ALASKAN WAY VIADUCT

EVALUATION OF GRAY'S RETROFIT PROPOSAL

Prepared for the
Washington State Department of Transportation

By
T.Y. Lin International

Figure 21a Floorbeam curvature ductility demand, retrofitted structure, design earthquake, upper level

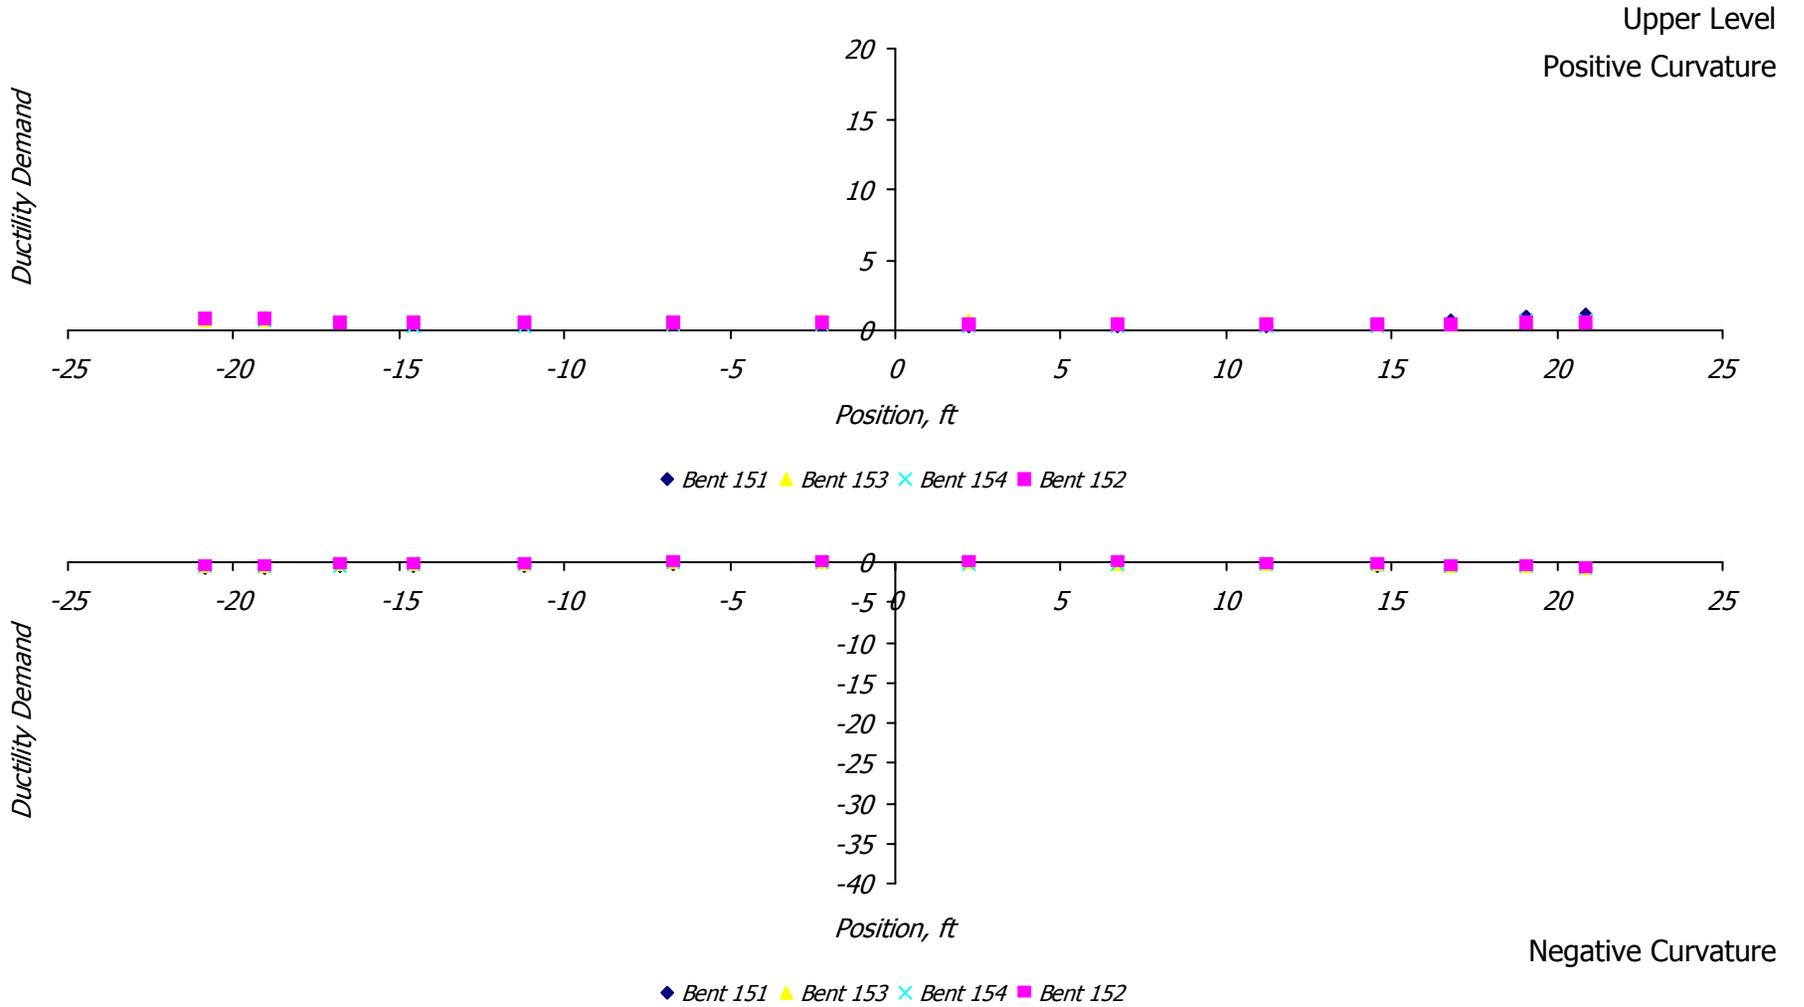
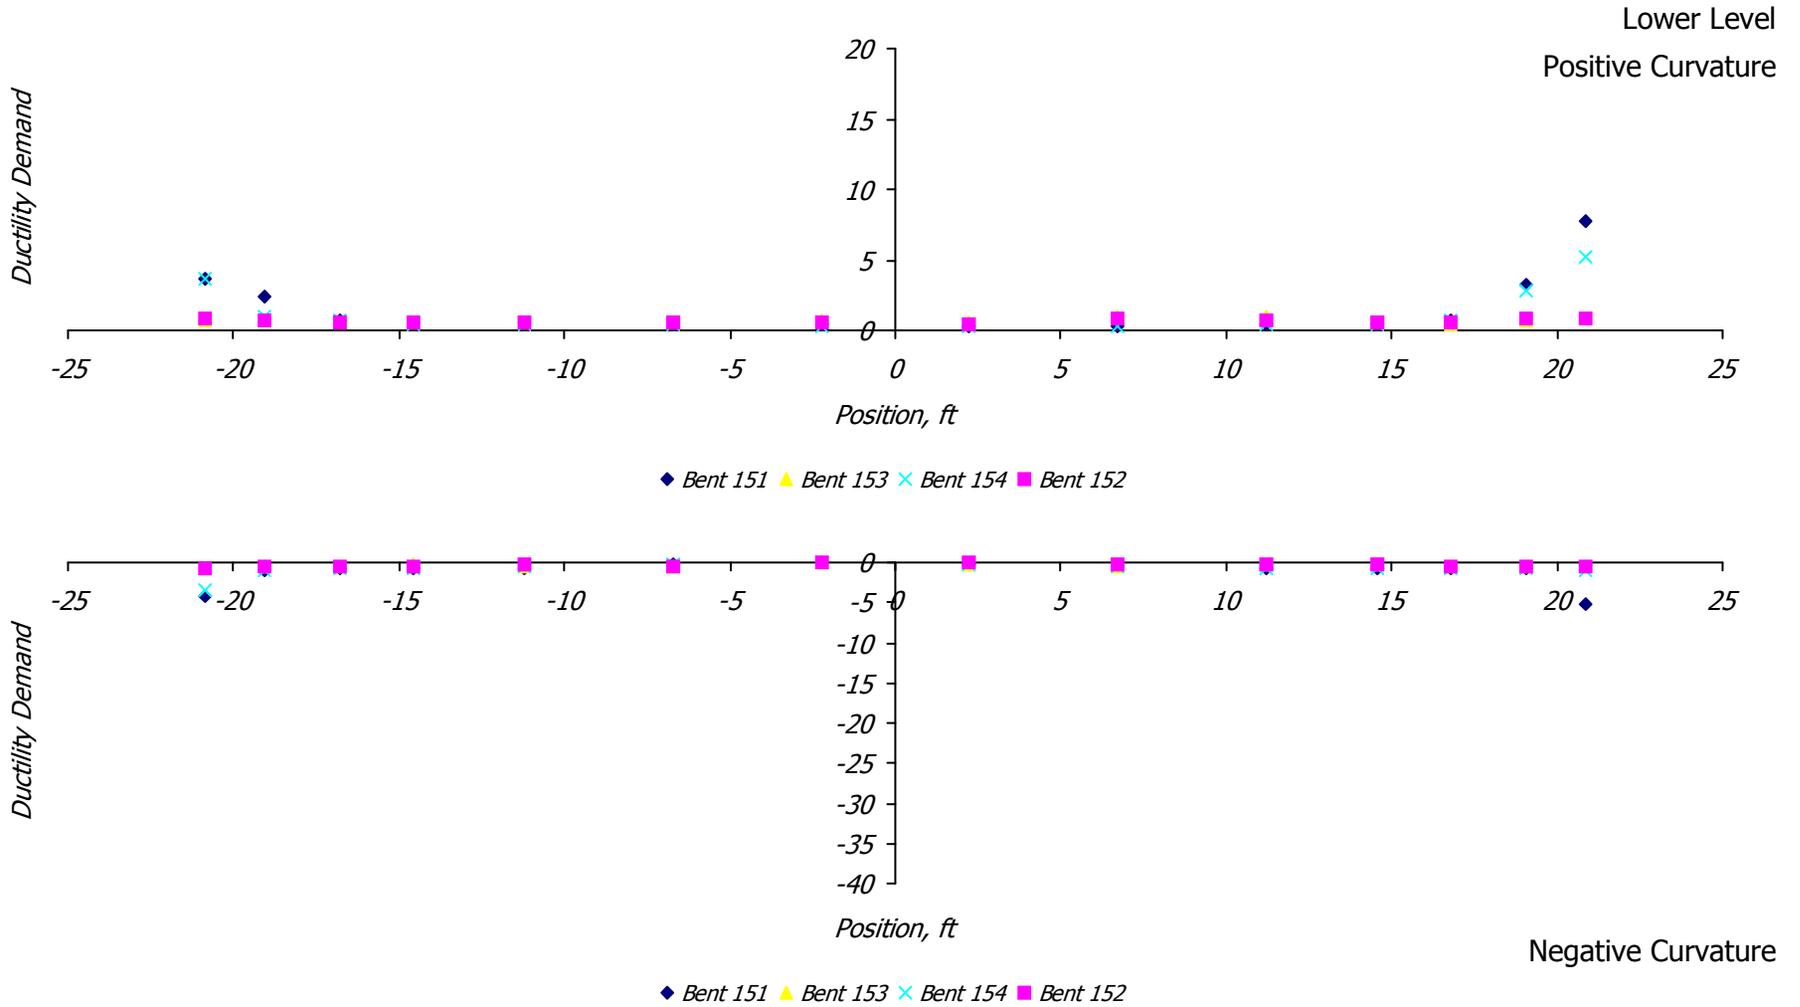
For the design earthquake, the curvature ductility demands on the floorbeams are summarized in Figure 21. The largest demands occur on the lower level floorbeams, and are up to 7.8 in positive bending and 5.2 in negative bending. These values are large enough to cause significant cracking and yielding of reinforcement, but within the limits for repairable damage provided that there is not major degradation in development of reinforcing details.

Figure 22a Floorbeam curvature ductility demand, retrofitted structure, expected earthquake, upper level

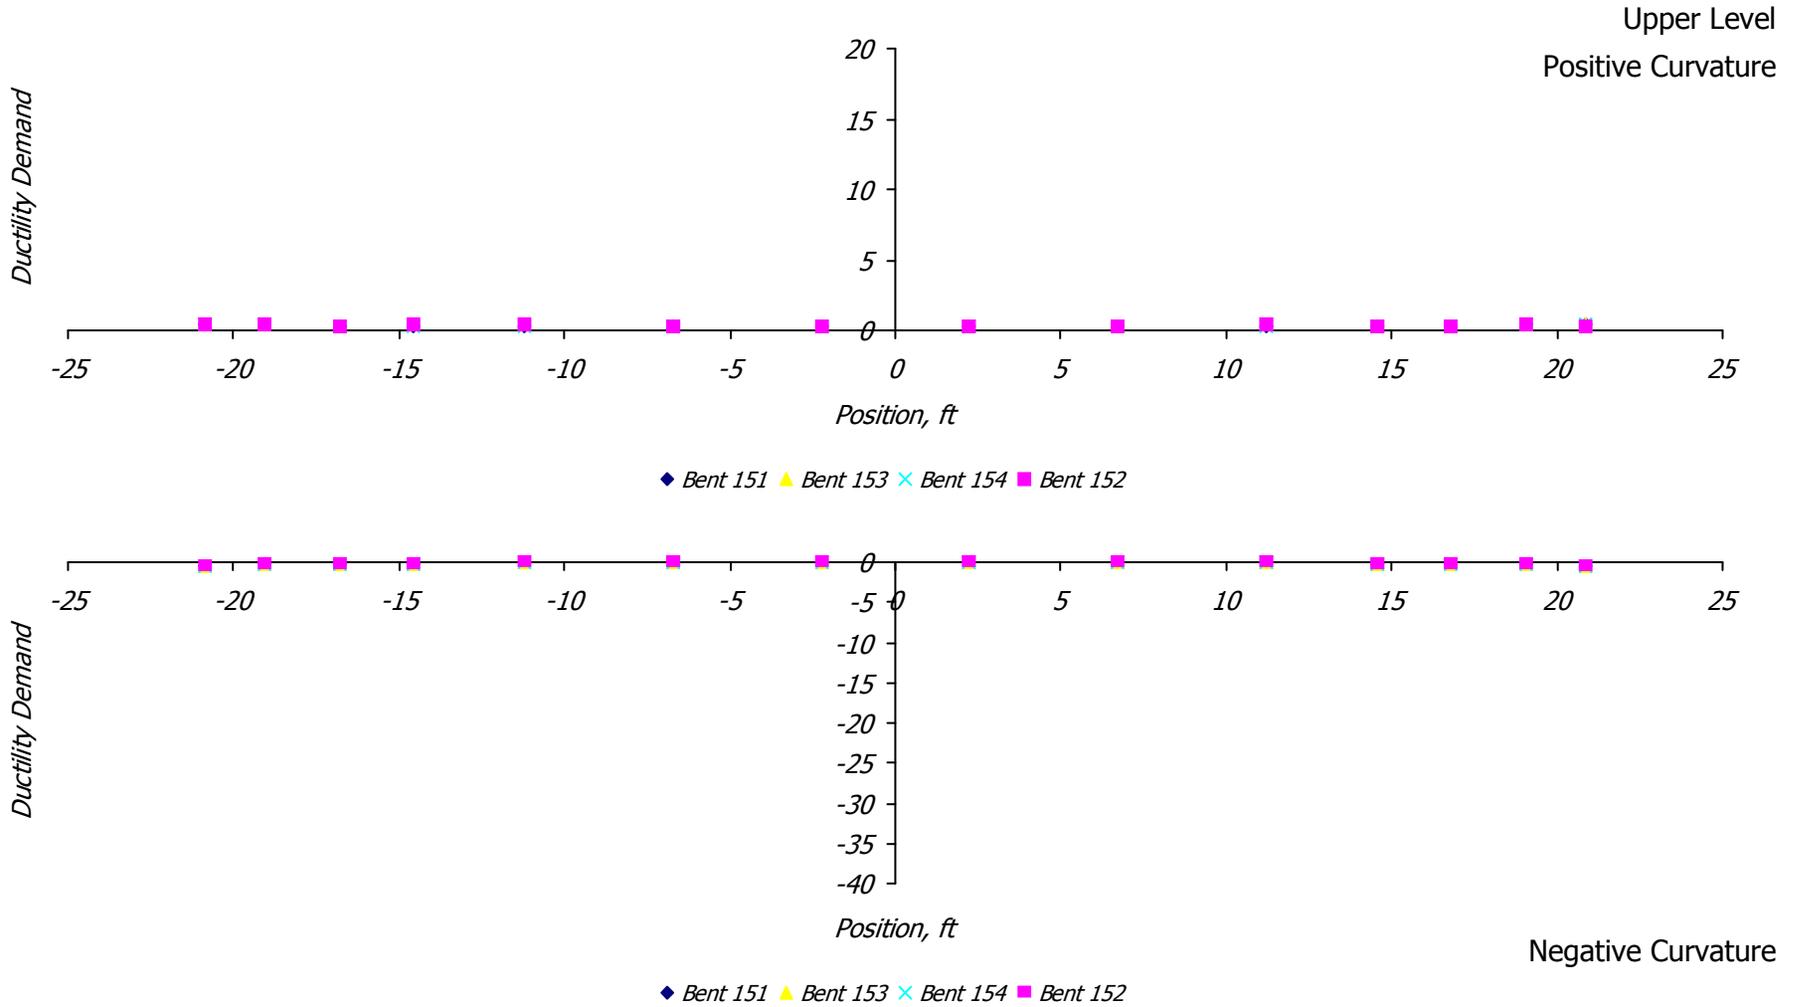
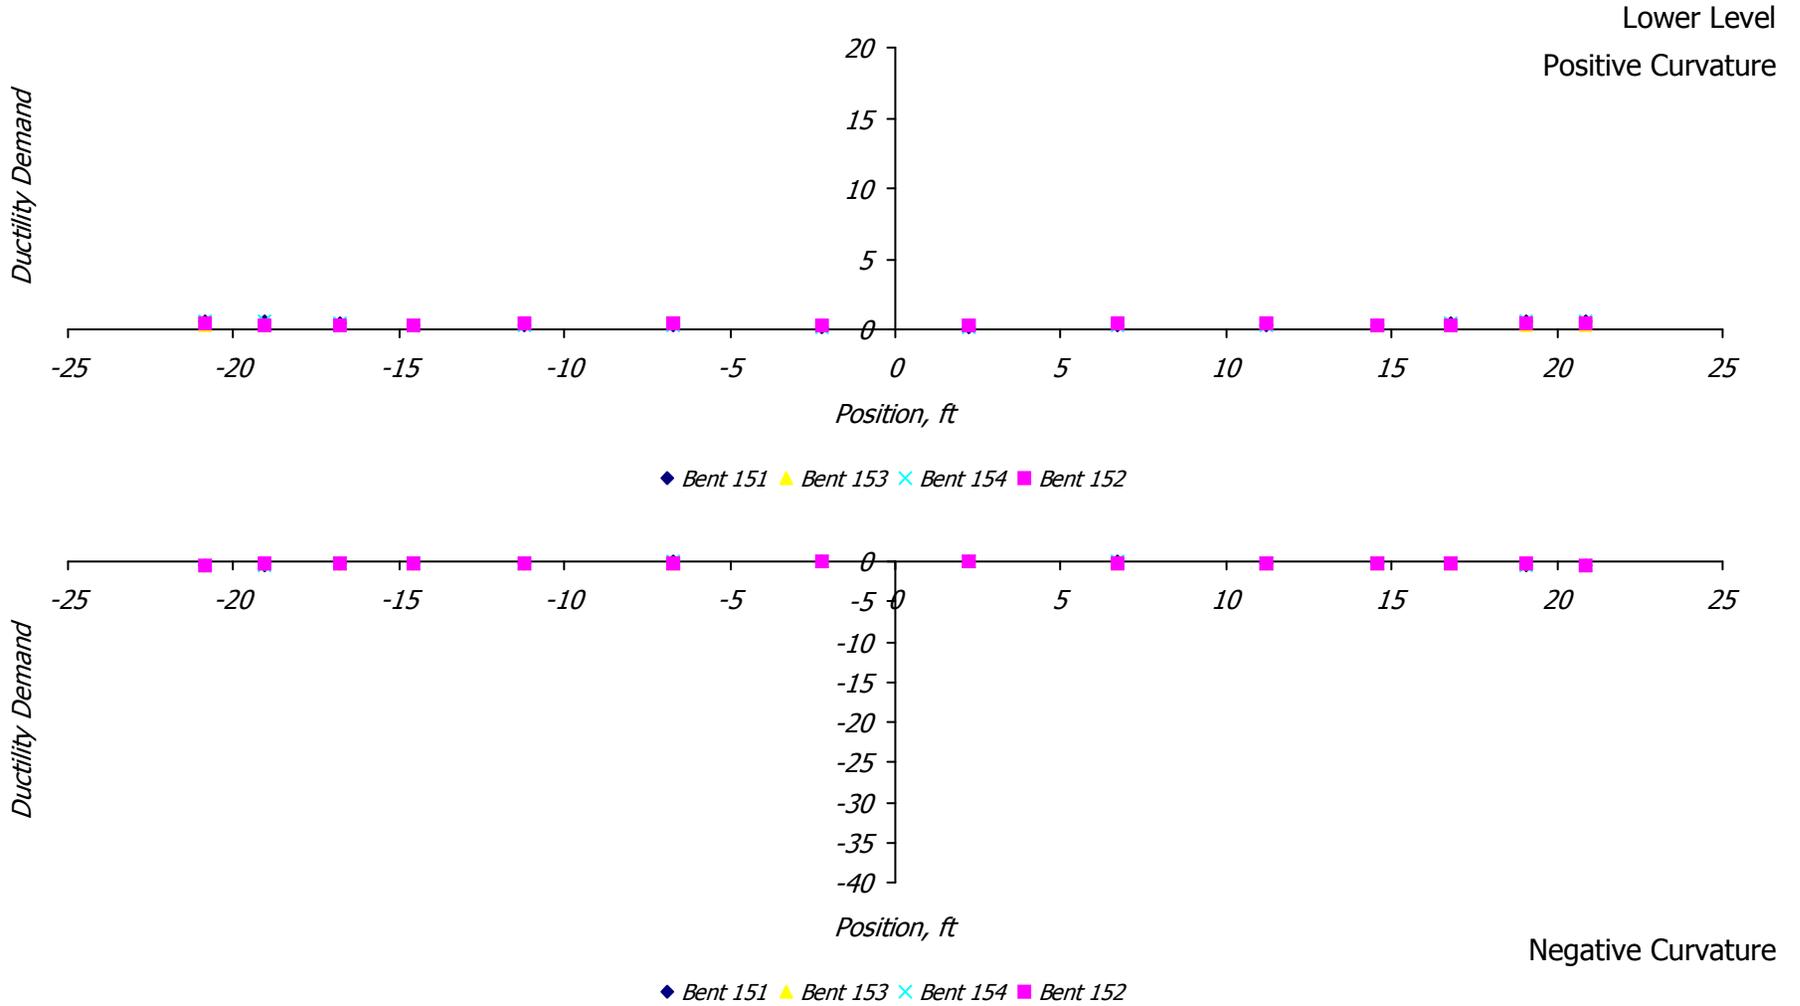
For the expected earthquake, the curvature ductility demands on the floorbeams are summarized in Figure 22. They are all less than unity; normally, damage would not be expected. It is likely that any pre-existing flexural or shear cracks would be further widened by a seismic event, however.

Figure 23a

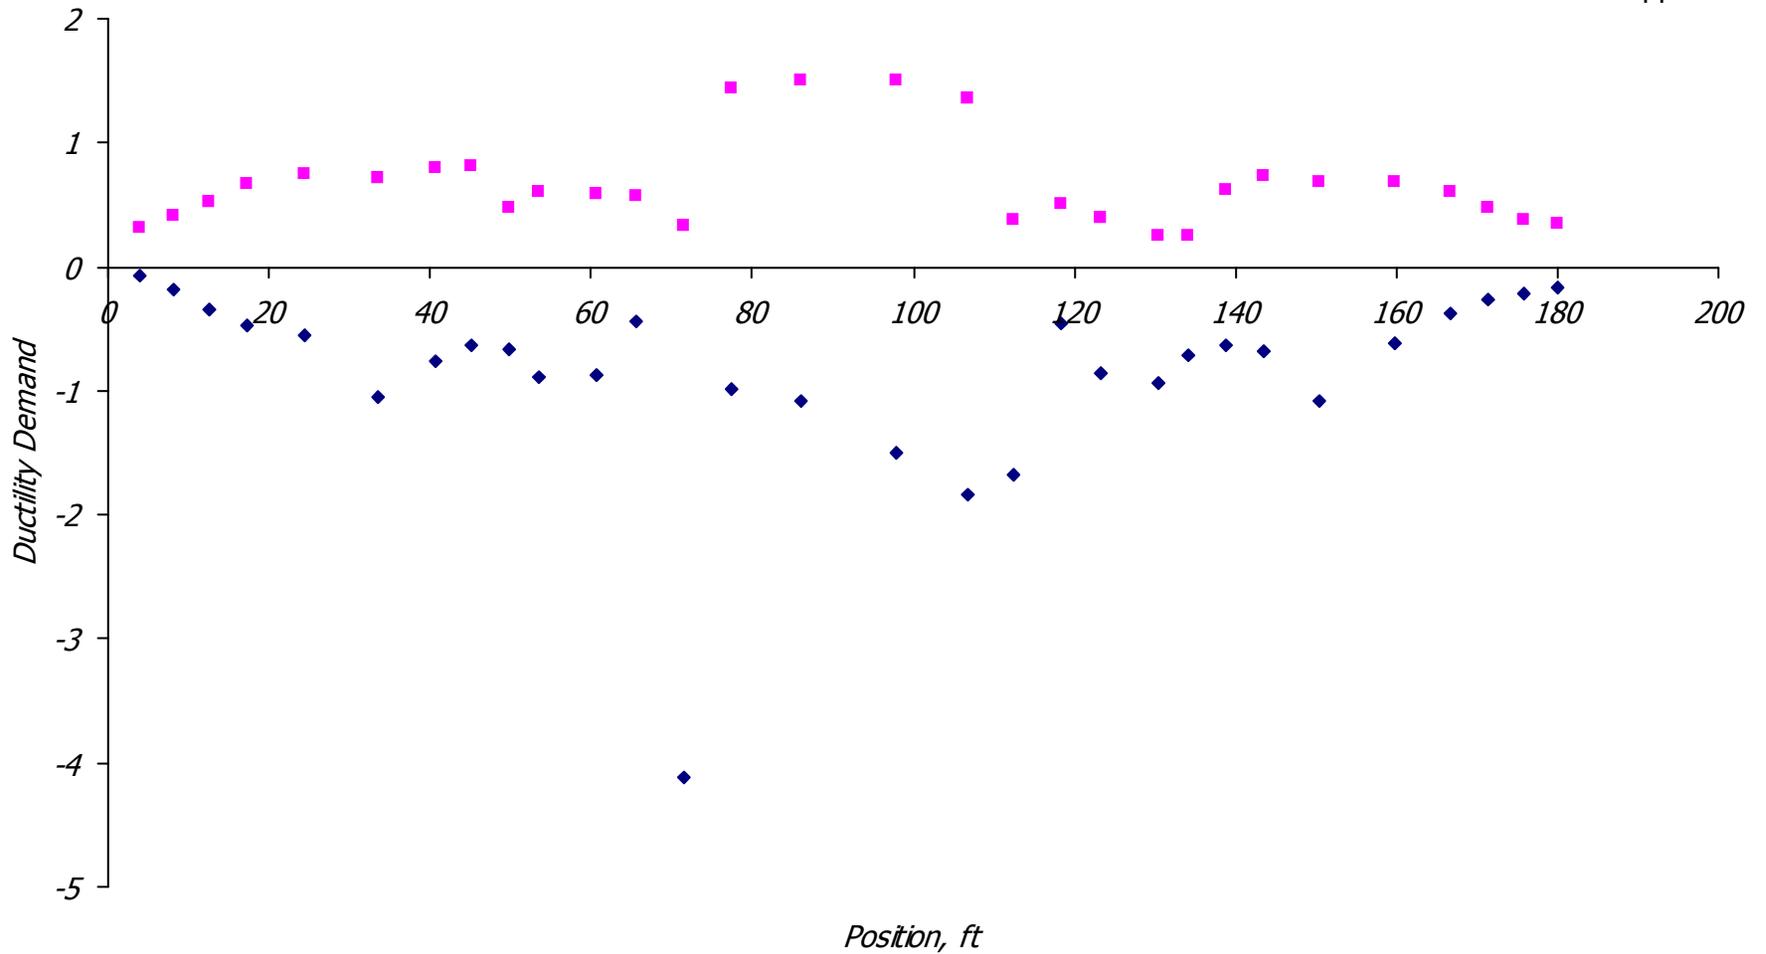
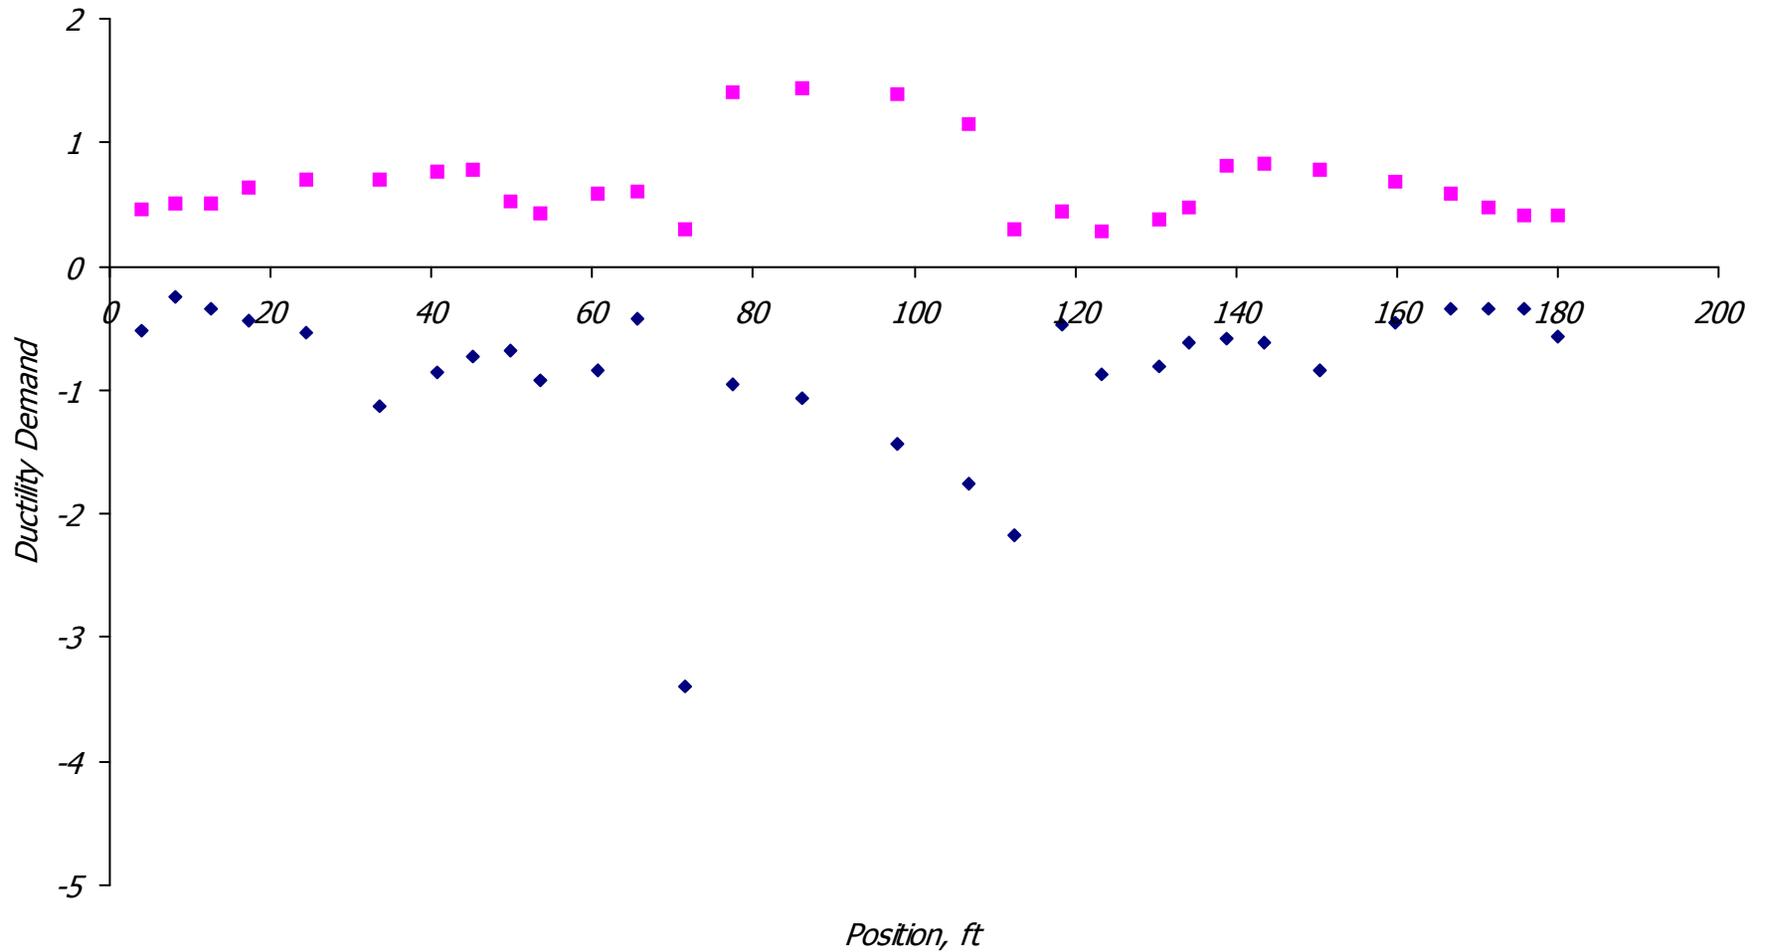
For the rare earthquake, the curvature ductility demands on the edge girders are summarized in Figure 23. There are separate plots for the upper and lower level girders; positive (∪) and negative (∩) demands are plotted together. Although yielding is indicated, the curvature ductility demands are modest and comfortably less than the capacity of the girders. The largest demand occurs in negative bending, at some distance from a column face, near a cut-off of top reinforcement. It may be that the demands on the girders are small because the longitudinal auxiliary frames prevent displacement of the upper level of the structure relative to the lower level.
